X3T9.2/91-126R1

MEMORANDUM -- 16 Aug 1991 -- Revised 9 Sep 1991

SUBJECT: Comparison of S/E Cable/Terminator Options for SCSI-3

Figure 1. V-I Characteristics

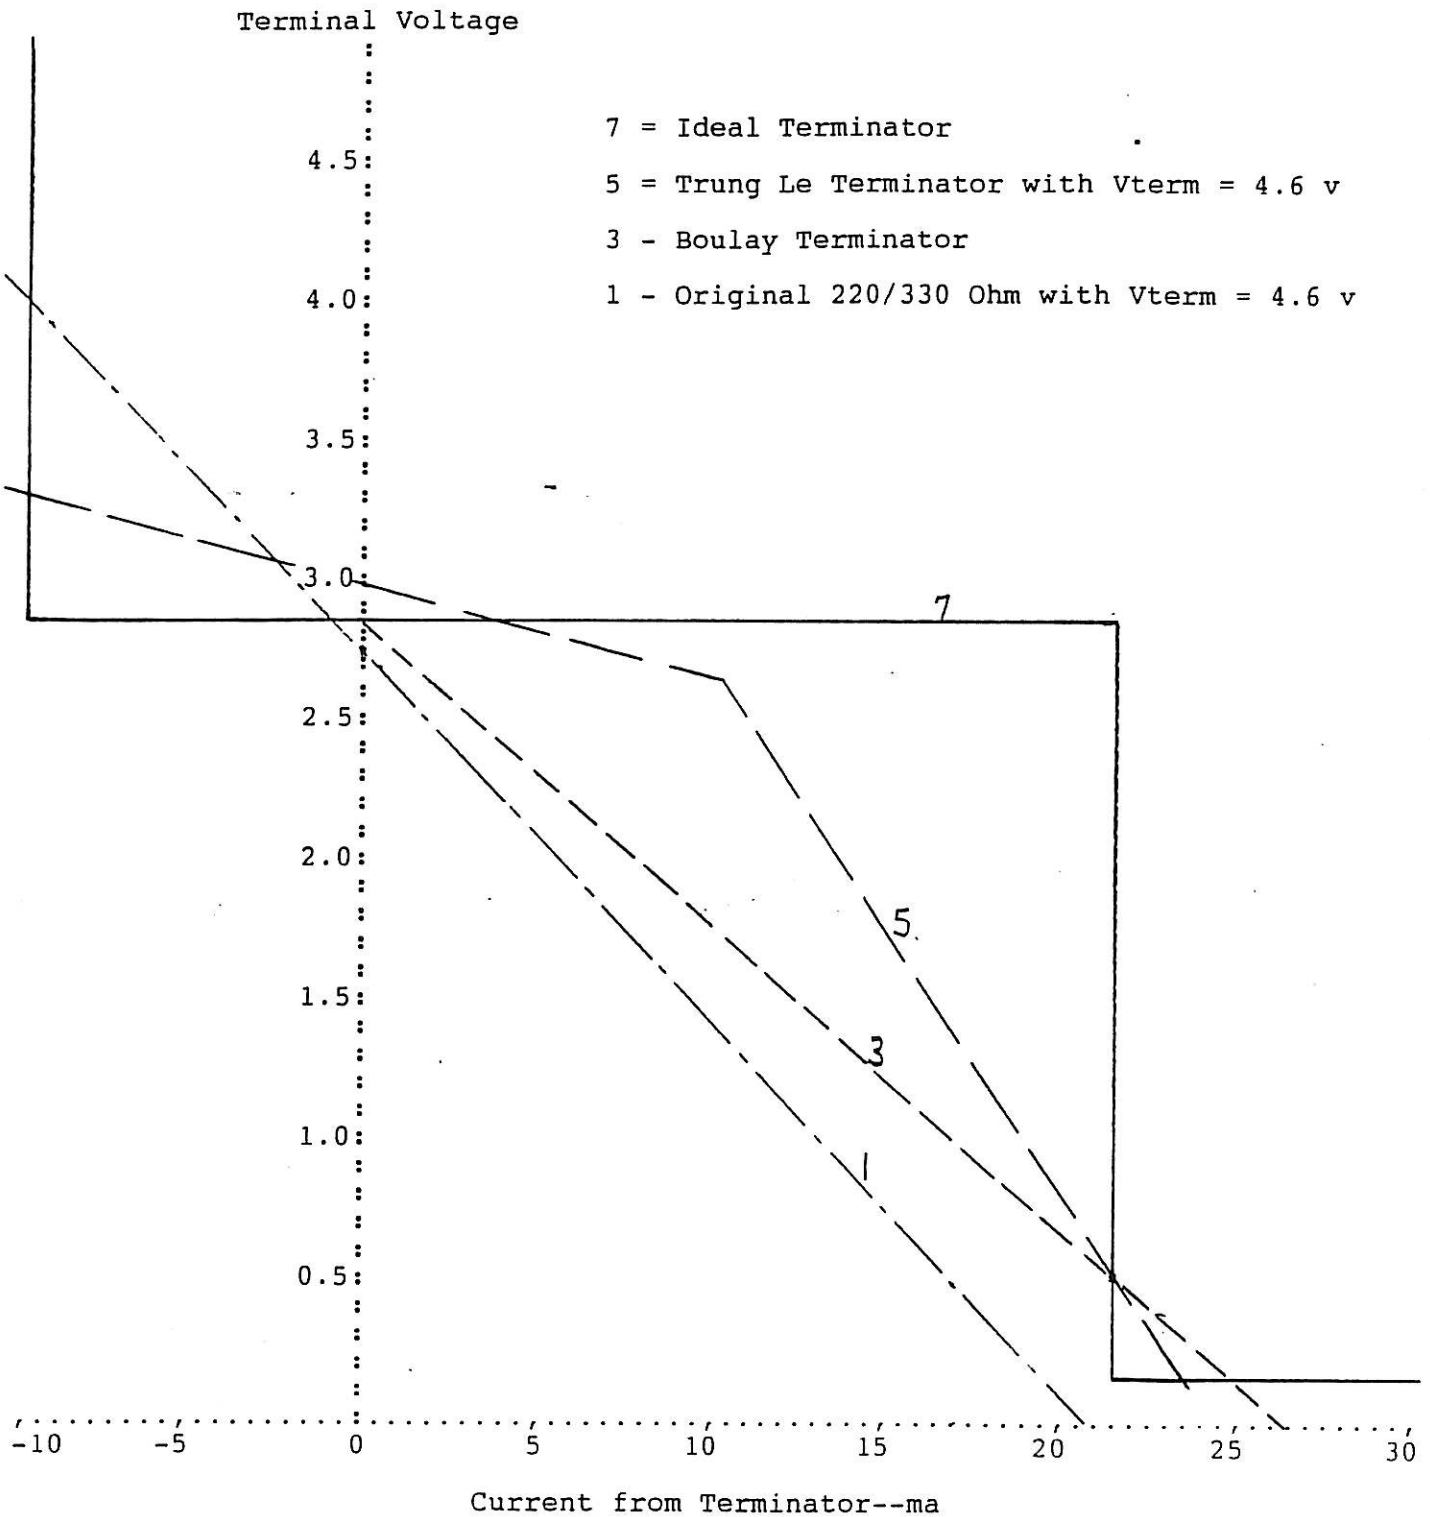
The concept presented in Option 7 above is illustrated in Figure 1 below. The heavy solid line represents ideal terminator functioning. Whenever the line terminal at the terminator is below 2.85 volts, the terminator delivers 21.4 ma into the line, creating maximum drive to bring the line up when released without exceeding the driver rating when the line is asserted. (This target current is chosen to be 1 ma below the absolute maximum 22.4 ma.) Whenever the terminal voltage achieves 2.85 volts, whatever current the line requires to maintain that voltage is provided. (Note: these statements apply to the transient conditions following line switching; in the steady state, conventional line values obtain.) If the line terminal voltage tends to be pulled above 2.85 volts by ringing effects, it desirably should be clamped to provide immediately signal stability and reduce bus noise. If, on the other hand, it is pulled above 2.85 volts by active negation, the current drawn by the terminator from the line should be limited to a safe value, e.g., - 10 ma. Finally, if the line terminal voltage tends to be drawn below e.g. 0.15 volts by transient conditions, it should be clamped at that level. (Note: if desired, it can be posited that this terminator has an effective, or average, impedance

The Trung Le terminator characteristic is calculated from its circuit and from the test results Kurt Chan reported in 91-93. The fact that it has similar end points to the Boulay characteristic but is much closer to the ideal characteristic in shape suggests the reason for its success in difficult circumstances. The anemia of the the current provided by the 220/330 ohm terminator even at $V_{term} = 4.6$ volts is obvious. For a truly low V_{term} , the current inadequacy becomes very serious. The 187/267 ohm terminator, by contrast, has the same characteristic as the Boulay terminator for $V_{term} = 4.85$ v and provides 17% more current than the 220/330 ohm terminator at all levels of V_{term} .

The Boulay characteristic is undefined in the active-negation, or negative-current, region because it depends on how many lines are asserted and how many negated.
